CAPELOUTO 42ND

4505 42ND AVENUE SW

DESIGN REVIEW RECOMMENDATION II DPD #3016195 FEBRUARY FIFTH, 2015

3. SOUTH ELEVATION

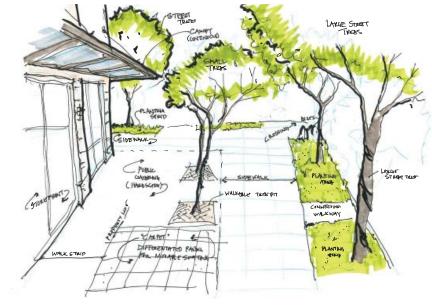
a The board encouraged the applicant to design the stair tower as shown in Option 3 continuing the massing and glazing along the south elevation.

As previously noted, the south facade of the building has been a challenge. Materials and patterns from the primary facades wrap the corners and transition to a more utilitarian material. A set back from the property line allows for windows in the upper levels.

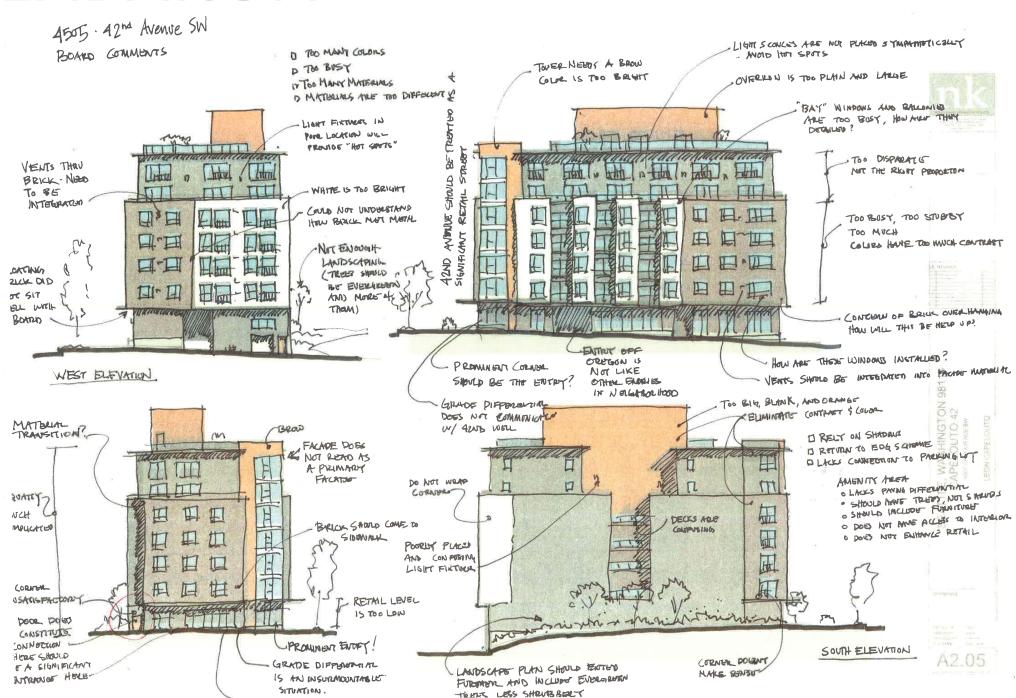
I. DESIGN CONCEPT: COMPARING THE MASSING OF THE PREFERRED OPTION AT THE 2ND EDG AND THE CURRENT DESIGN, THE BOARD NOTED THE BUILDING FACADES ARE DISJOINTED AND GAVE GUIDANCE TO SIMPLIFY THE ELEVATIONS. THEY EXPRESSED THAT THE PODIUM WORKS WELL ON SW OREGON ST AND THE ALLEY, BUT IS TOO SQUAT ON THE 42ND AVE SW. EAST FACADE.

- · Simplify the north facade; there are too many elements.
- · Simplify the east facade and design with vertical articulation.
- There was concern about the appearance of the lighting sconces at the upper levels and that they could create 'hot spots'. Light the facade from below or above.
- · Articulate the windows; either project or recess the window frames.

2 DESIGN OF THE STREET-LEVEL ALONG 42ND AVE SW: THE BOARD WAS CONCERNED THAT THE GENEROUS WIDTH FROM THE CURB TO THE BUILDING FACE WOULD NOT BE ACTIVATED WITH THE PROPOSED DESIGN.

- · Provide a main corner entry or a main entry on 42nd Ave SW to serve the plaza. Design for an additional door further south on the elevation.
- · Design a sitting area for the plaza to show how it would work.
- · Change the paving at the property line.
